Additional adjustment markings for the SK4 and SK6 print heads

Information

Position of the new markings:

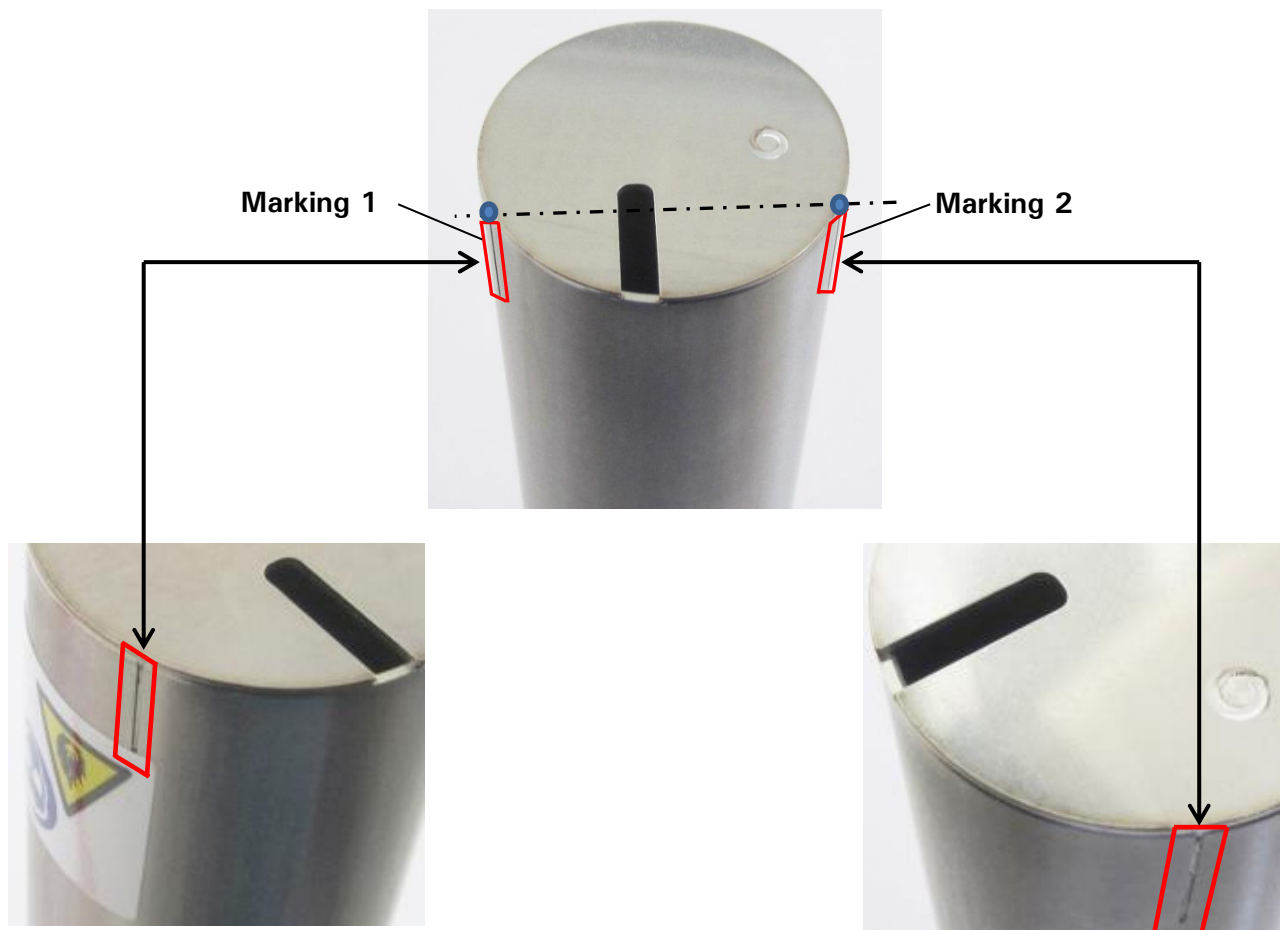
- From August 2017 (SK6), respectively by the end of 2017 (SK4) the print head covers for the JET3up and JET2neo printers are equipped with **two additional markings** at the ink-outlet.
- The great advantage of these markings are, that the print head- adjustment to the printed product will be essentially simplified.
- The new head covers are downward compatible to the previous covers and identical in regarding of the installation. Also the article numbers will remain the same.

(Serve as a guidance for the print head adjustment)

Parallel adjustment of the print head to the baseline of the printout

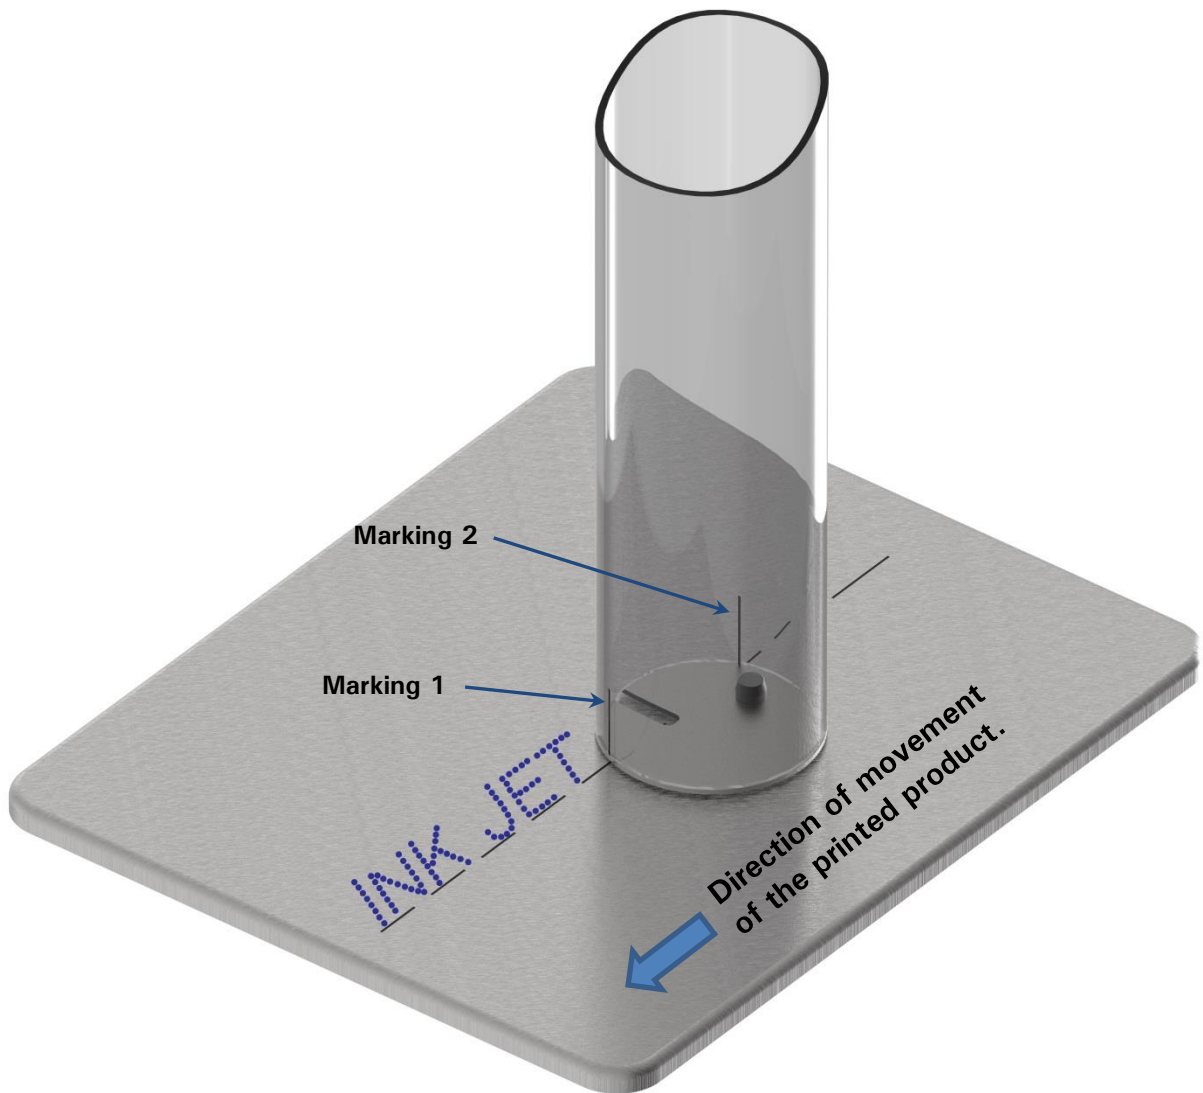
As shown, the print head will be adjusted via the both markings parallel to the baseline of the printout
